#### ADDENDUM NO. 7

**June 6, 2022**

# LIBERTY INTERMEDIATE SCHOOL ADDITIONS AND RENOVATIONS

This Addendum consists of Pages ADD 7-1 through ADD 7-4 and attached Addendum No. 7 from Gibraltar Design dated June 6, 2022 and consisting of 5 pages and 75 drawings.

D MP104

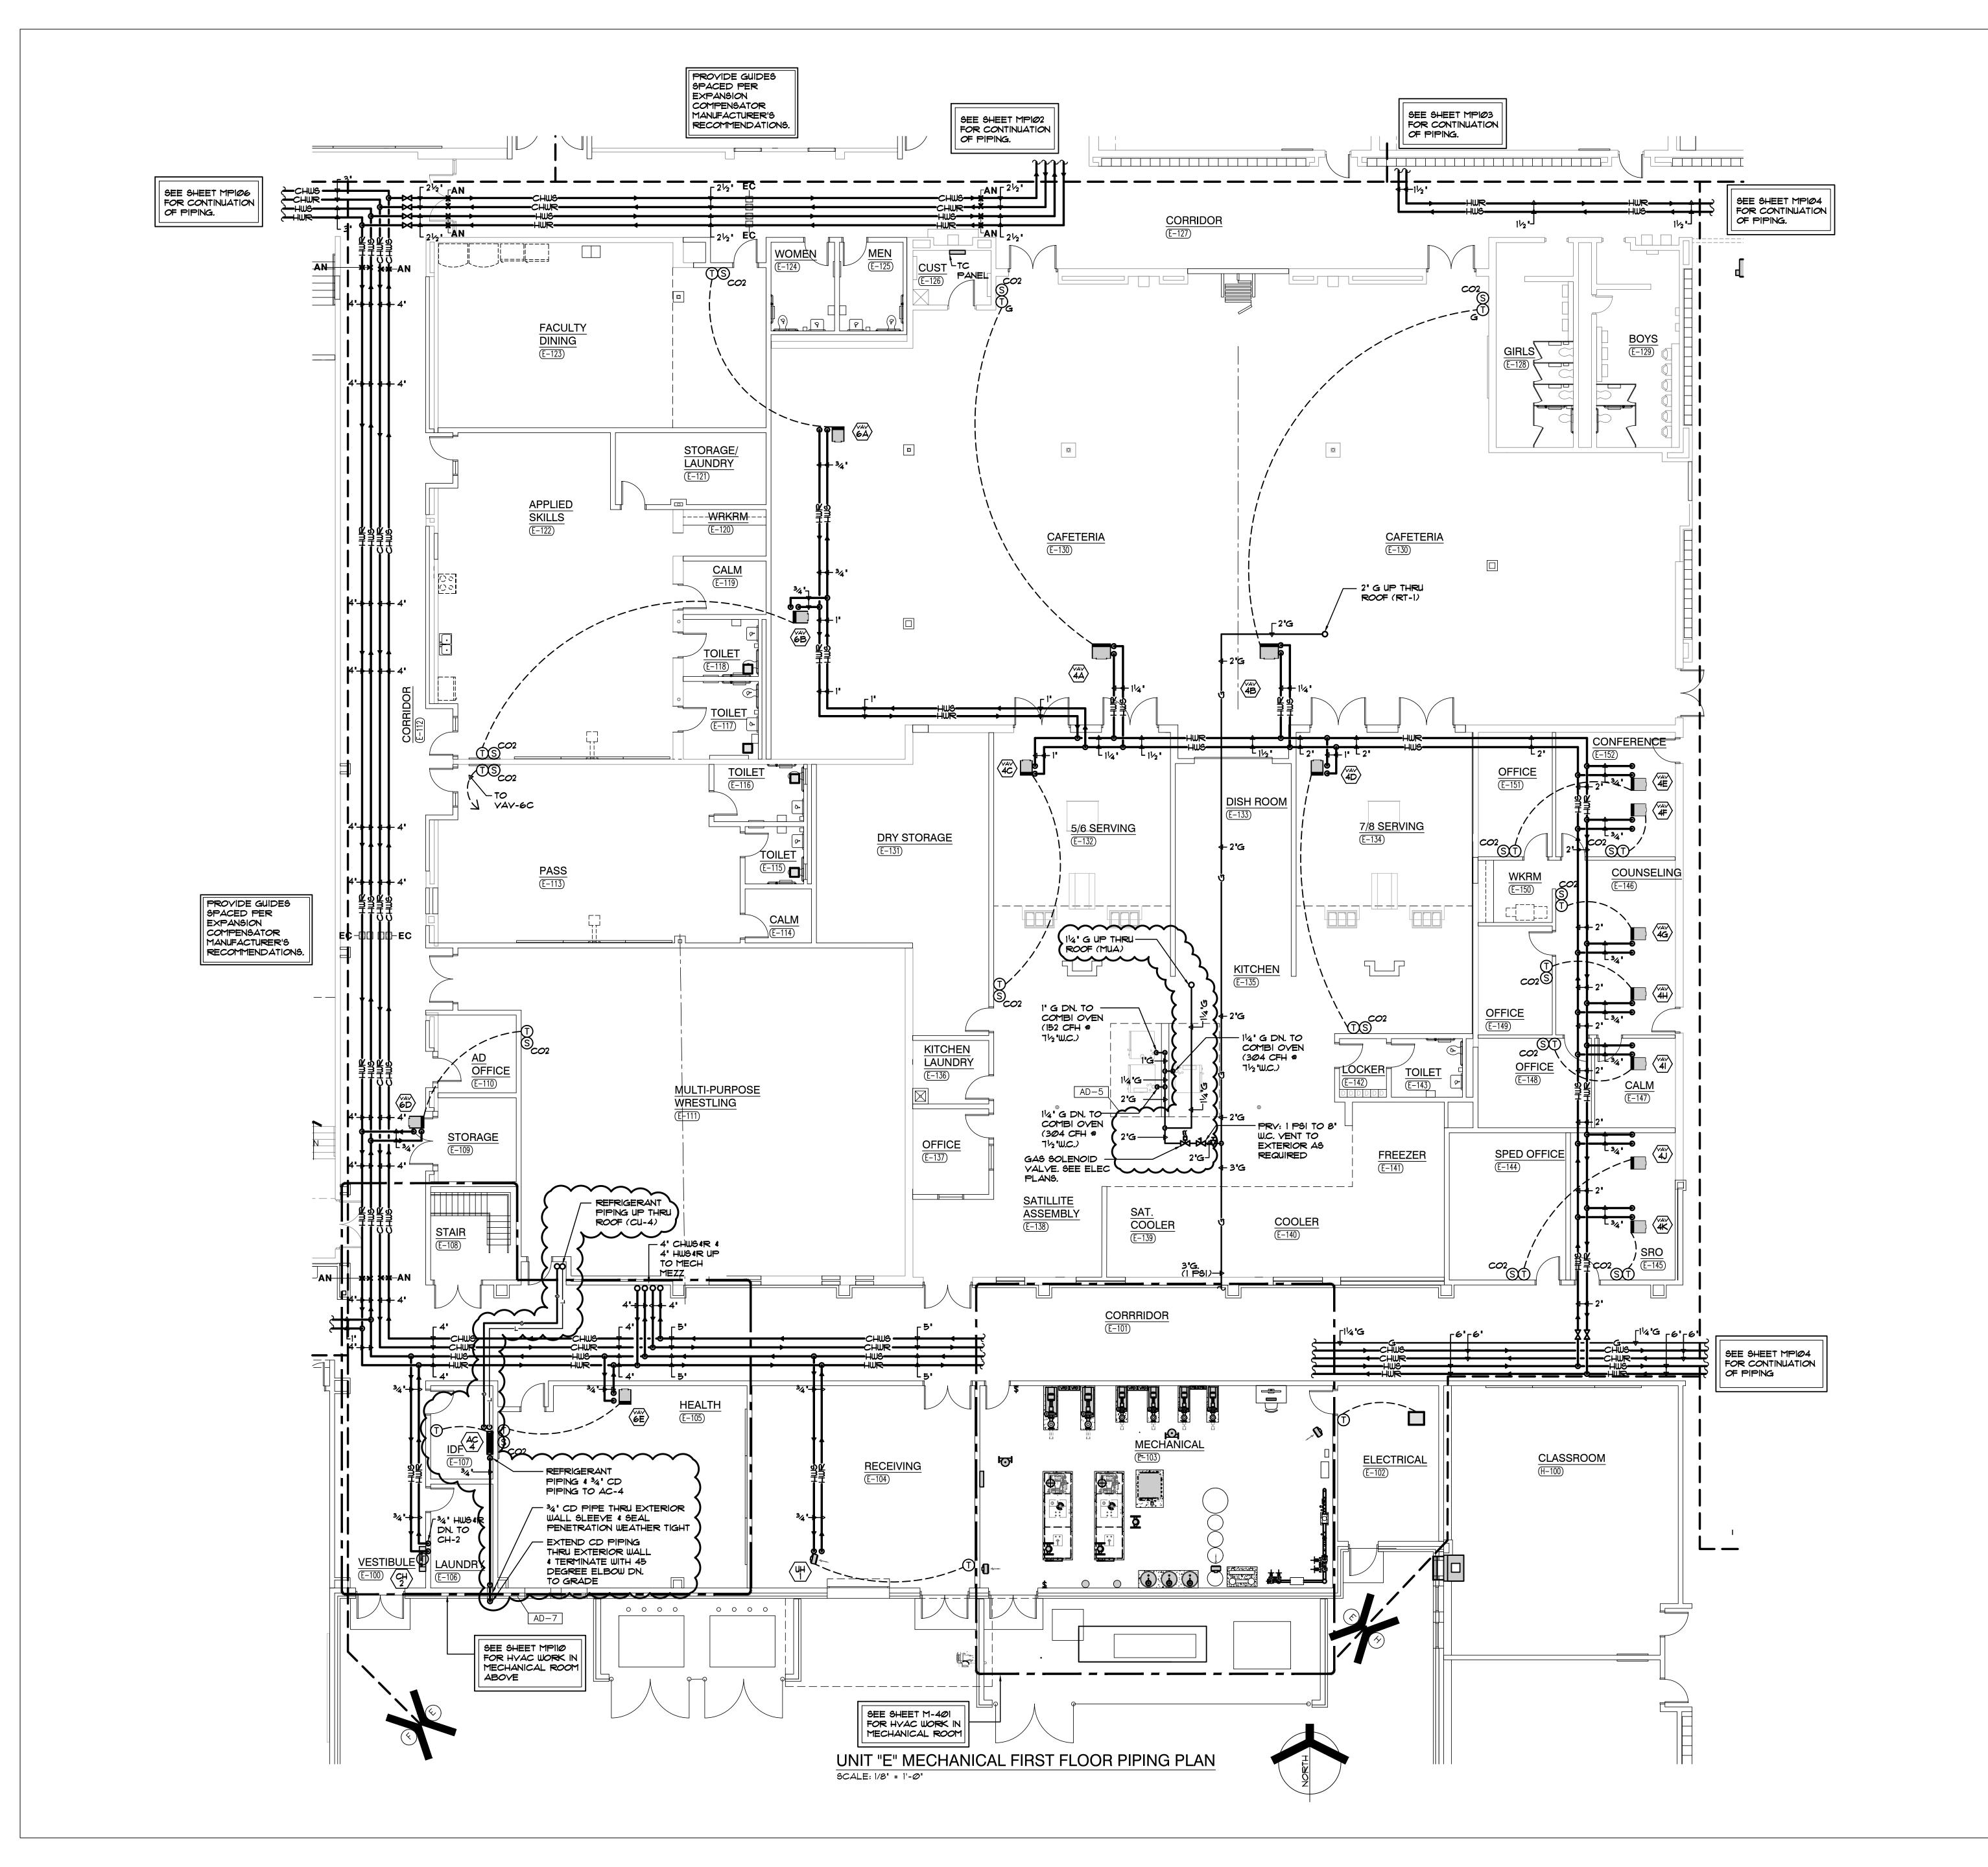
- A. Refer to revised full-size drawing included in this Addendum, for the following revisions:
  - 1. Added AC Unit, Refrigerant piping, and Condensate piping to IDF room.
  - 2. Revised pipe routing to Unit Ventilator.

© GIBRALTAR DESIGN SHEET M-301

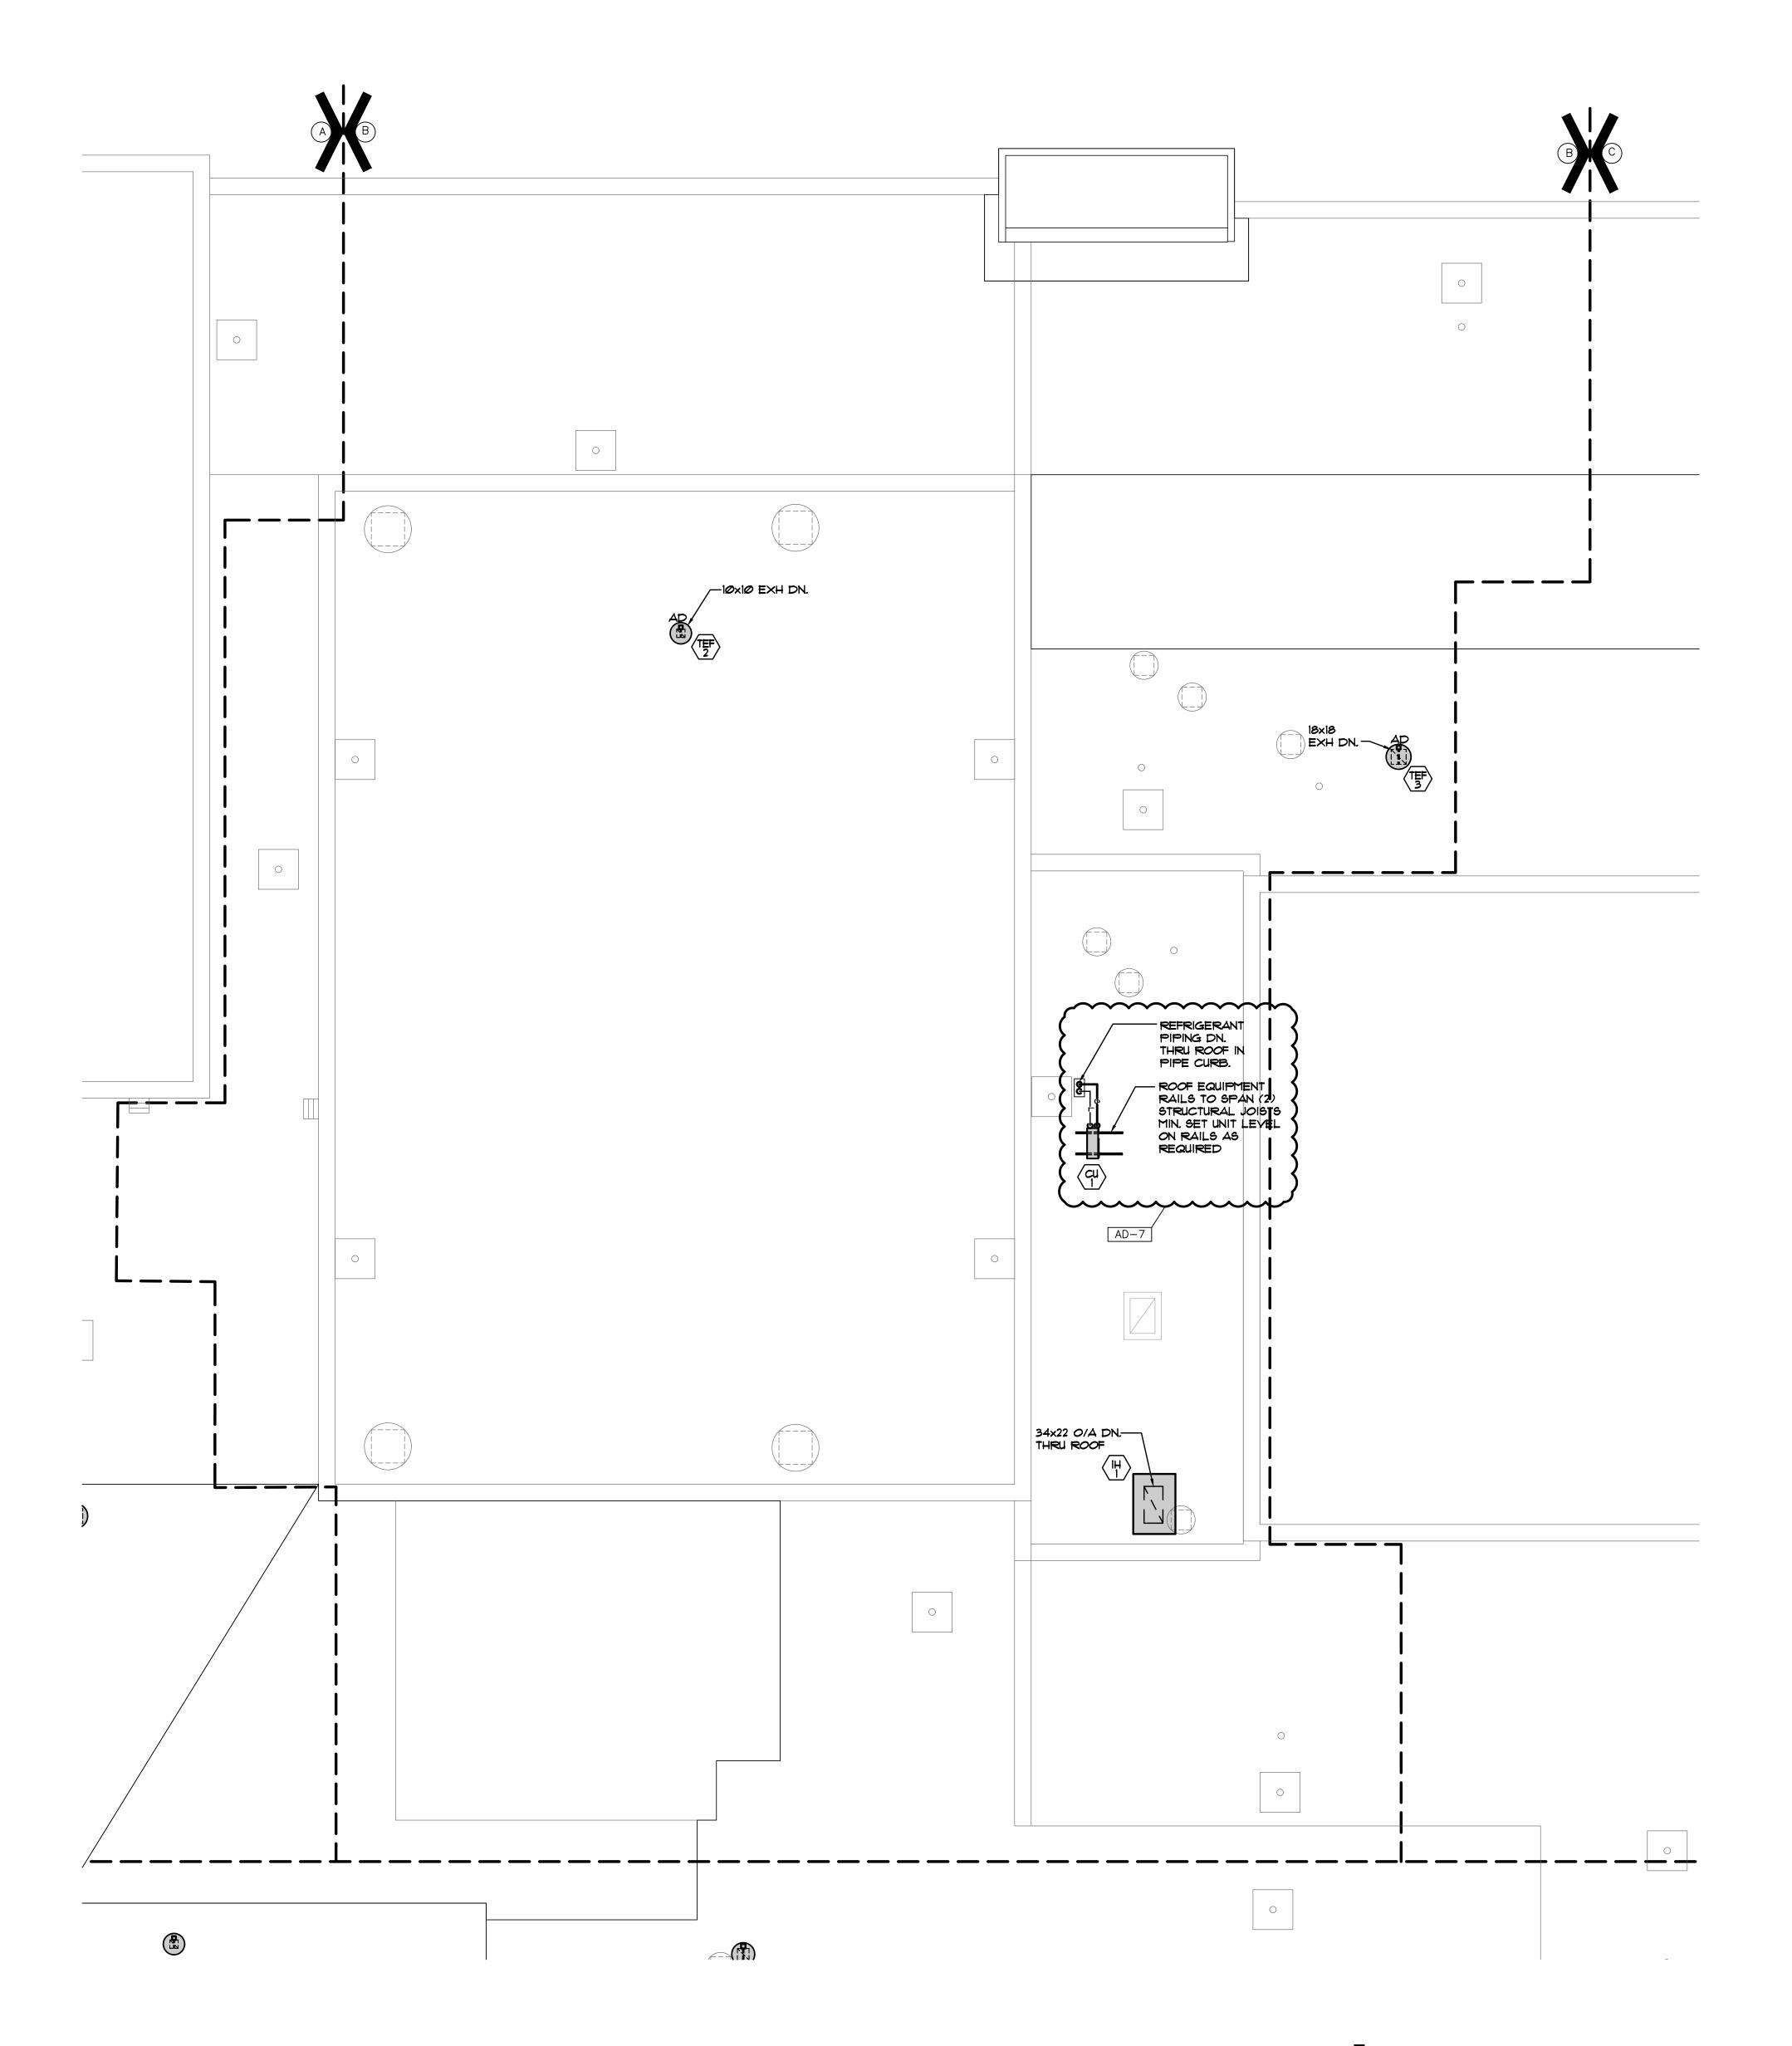
- A. Refer to Six (6) revised full-size drawings included in this Addendum, for the following revisions:
  - 1. Added Condensing unit and Refrigerant piping.

MECHANICAL SCHEDULES
AND NOTES

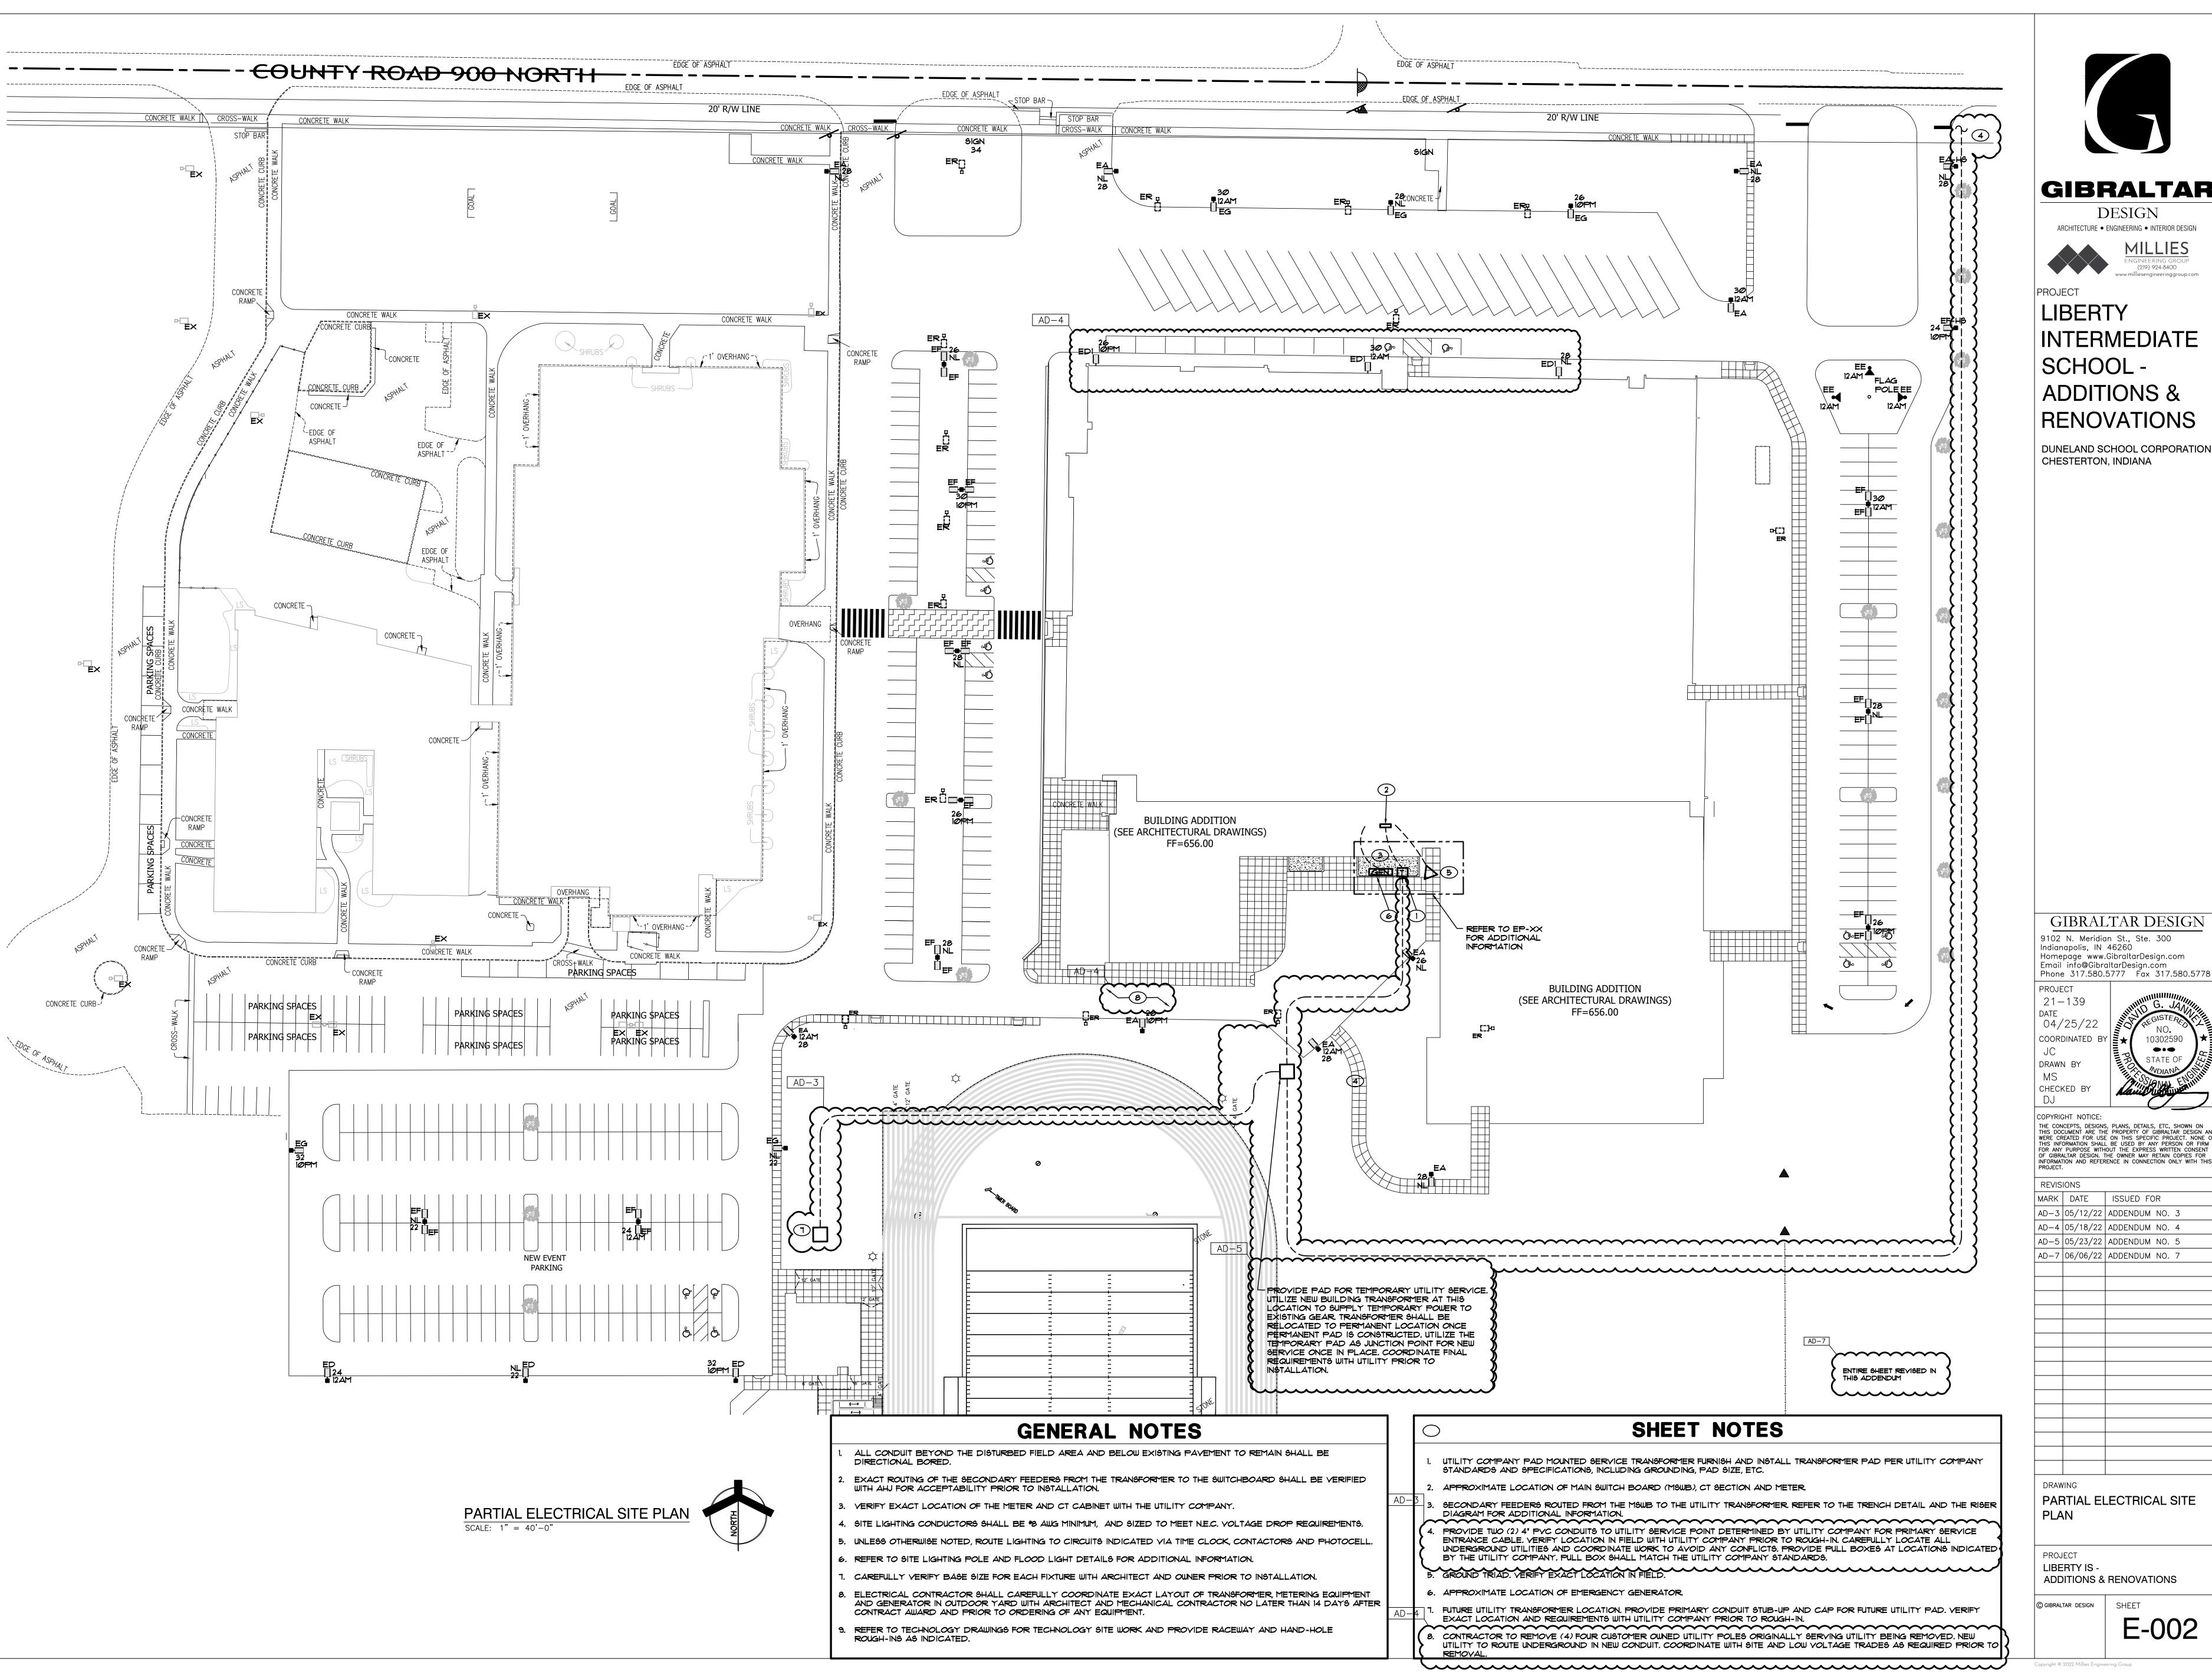
- A. Refer to revised full-size drawing included in this Addendum, for the following revisions:
  - 1. Added AC and Condensing Unit Schedule.
  - 2. Added schedule notes for AC and Condensing Units.
